DRAINAGE INFORMATION SHEET

RE: CONCEPTUAL G & D PLAN FOR MCDONALD'S/GAS STATION (J-14/D109)
RECEIVED AUG 10, 1999 FOR SITE DEVELOPMENT PLAN
ENGINEER'S STAMP DATED 7-29-99

RE: CONCEPTUAL GRADING AND DRAINAGE PLAN FOR GATEWAY APARTMENTS ON TRACT A-1, LOMAS CENTER (J14/D109), ENGINEER'S STAMP DATED 5/8/95.

FLOOD HAZARD MAP

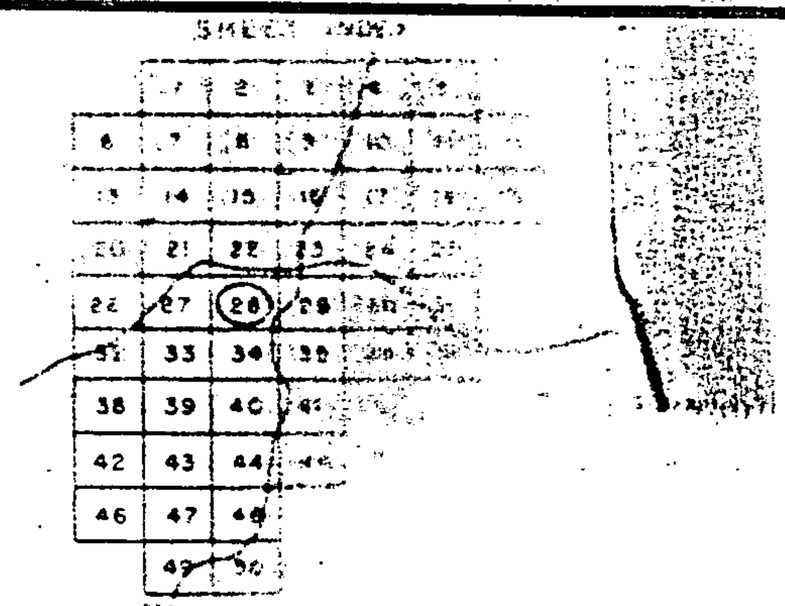
Zone AH Flood Zone (100yr),
Elev = 4954
Bldg Floor Elev = 4957.5
